Job No: 2023-5274
File Ref: N03-CC-Transport Addendum F2 (241127)
Date: November 2024
Job Title: 148-154 High Street, Uxbridge

Subject: Transport Assessment Addendum: GLA / LBH Response

Figure 1: Cycle Lift Location in Relation to Ground Floor and Basement

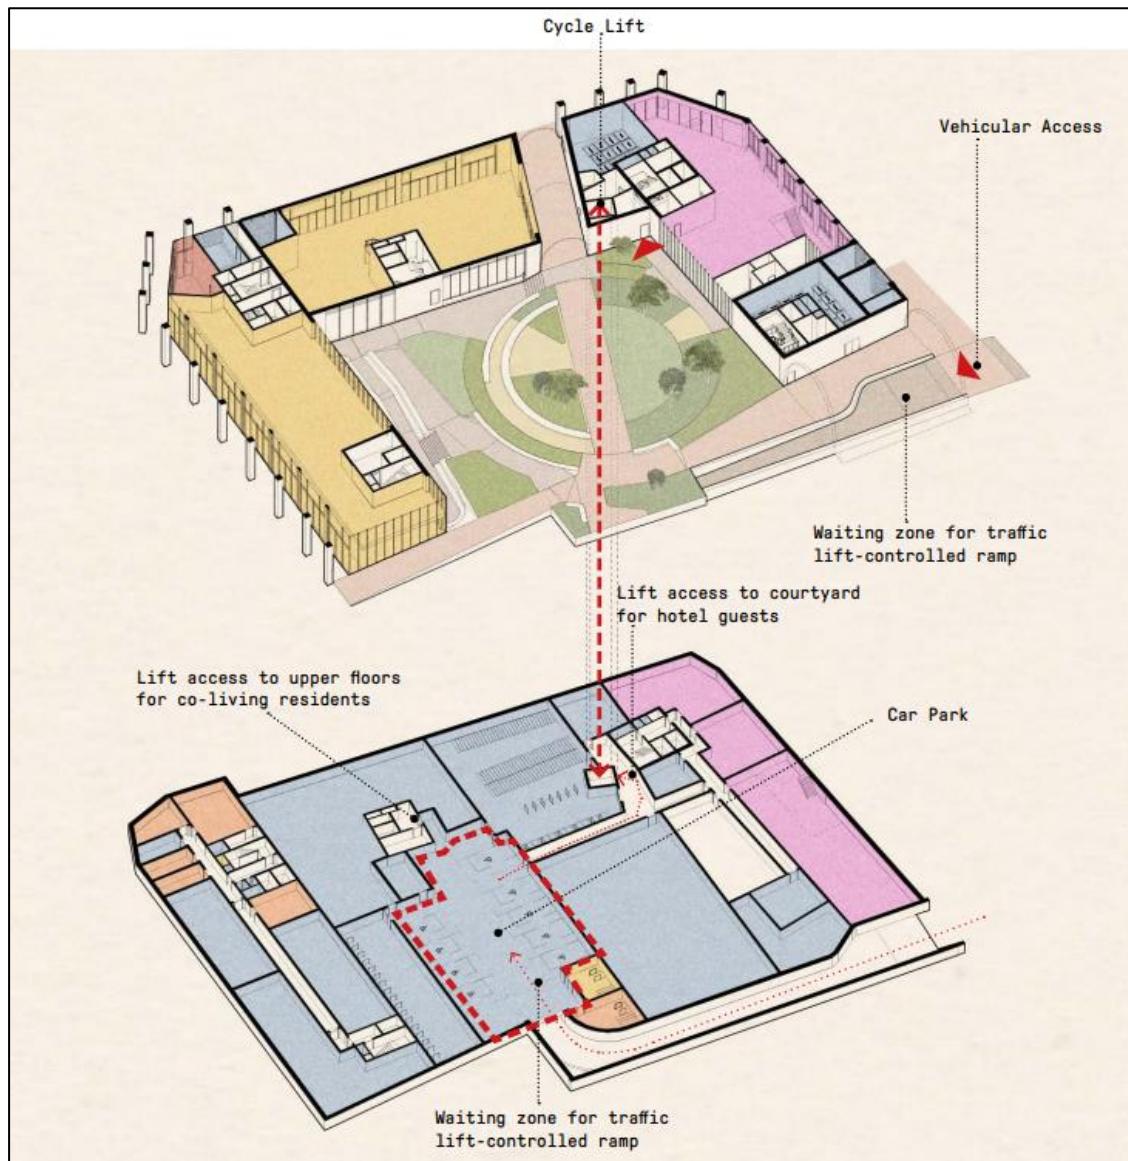
GLA Comment: *73. The location of the dedicated cycle lift to the basement should be clarified, clearly noting the access to the lift at ground floor level. Access to basement cycle parking areas should be safe and legible, preferably via the same external door as the pedestrian access to the core.*

LBH Highways Comment: *The Highway Authority notes that the outside door between the lift and pocket park is under 1.2m wide, the Highway Authority believes that there is scope to widen this doorway to 1.2m allowing this matter to be addressed by way of a planning condition*

62. The cycle lift (which will be used by pedestrians and cyclists for all users of the development to travel between the ground floor and basement levels) can be accessed from the north eastern corner of the courtyard, accessible via a private lobby door to provide security which can be accessed by authorised users including pedestrians and cyclists. Appropriate signage will be provided to provide ease of access to all users.

63. **Figure 1** is extracted from the submitted Design and Access Statement shows the location of the cycle lift in relation to both the ground floor and basement.

64. This is agreed and the Applicant accepts this being secured by way of planning condition.
